UNITED STATES PATENT AND TRADEMARK OFFICE

APPLICATION NO.	FILING DATE	FIRST NAMED INVENTOR	ATTORNEY DOCKET NO.	CONFIRMATION NO.
09/997,494	11/19/2001	Alex P. Weaver	WEAVER.PT1	5181

Office Action Summary

DETAILED ACTION

FIG. 5

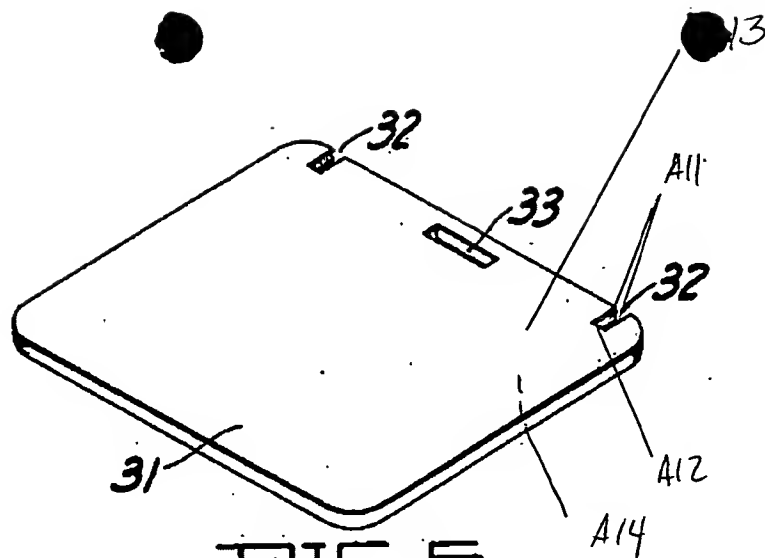
Regarding claim 1, Scarlett discloses in Figures 5 and 8 a double locking mortise joint comprising a first member **A1** and a second member **31**.

The first member **A1** has a first mortise **18**, a first contact surface **A7**, and a second contact surface **A8**. The first mortise **18** is generally perpendicularly with respect to an axis **A3** of the first member **A1**. The first mortise **18** has a gusset top **14**, a head bottom **A5** and a first mortise end **A6**. The gusset top **14** extends generally perpendicularly outward with respect to the axis **A3**. The head bottom **A5** is opposite to and generally parallel to the gusset top **14**. The first mortise end **A6** is generally parallel to the axis **A3** and connects the gusset top **14** and the head bottom **A5**. The second contact surface **A8** is next to the first mortise end **A6**.

The second member **31** has a second mortise **32**, a top surface **A13**, and a bottom surface **A14**. The second mortise **32** has two opposing sides **A11** being generally parallel to each other. The second mortise end **A12** connects the sides **A11**. The top surface **A13** and the bottom surface **A14** are next to the second mortise end **A12**.

Regarding claim 3, the first mortise **18** further comprises a first mortise corner **A15** and a second mortise corner **A16**. The first mortise corner **A15** is located between the first mortise end **A6** and the head bottom **A5**. The second mortise corner **A16** is located between the first mortise end **A6** and the gusset top **14**. The first mortise corner **A15** or the second mortise corner **A16** is square-edged.

FIG. 8

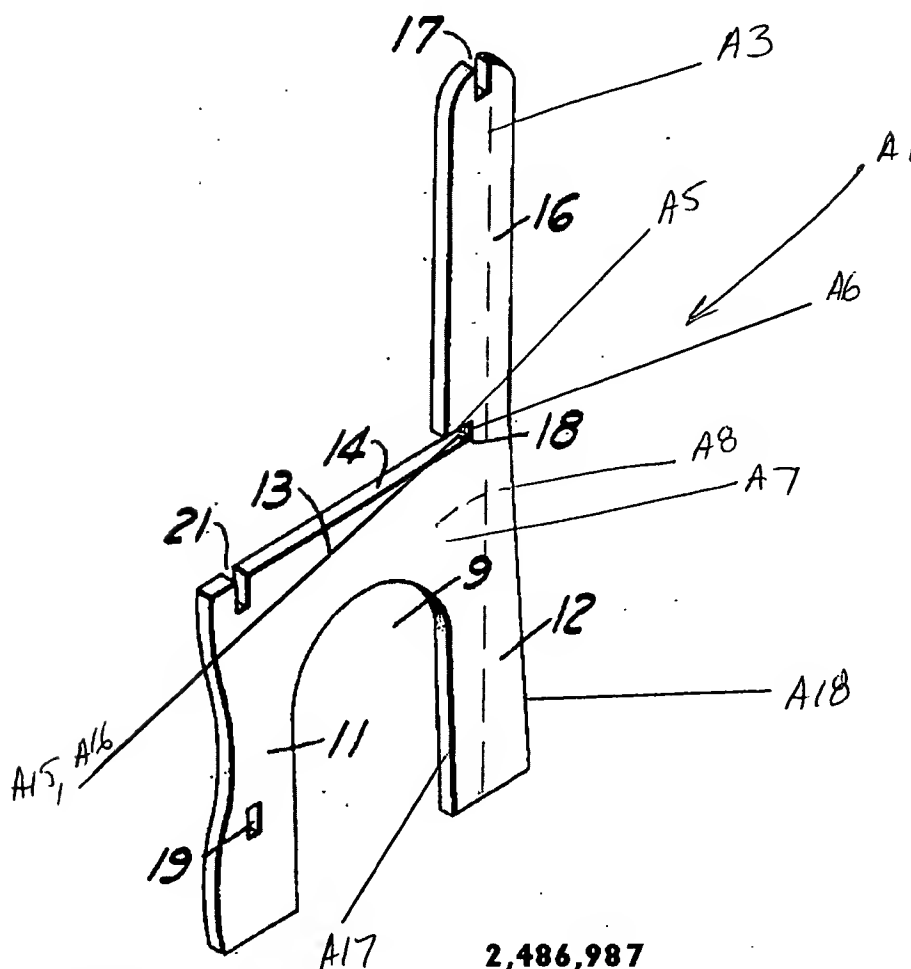
Regarding claim 4, the first mortise corner **A15** and the second mortise corner **A16** are square-edged.
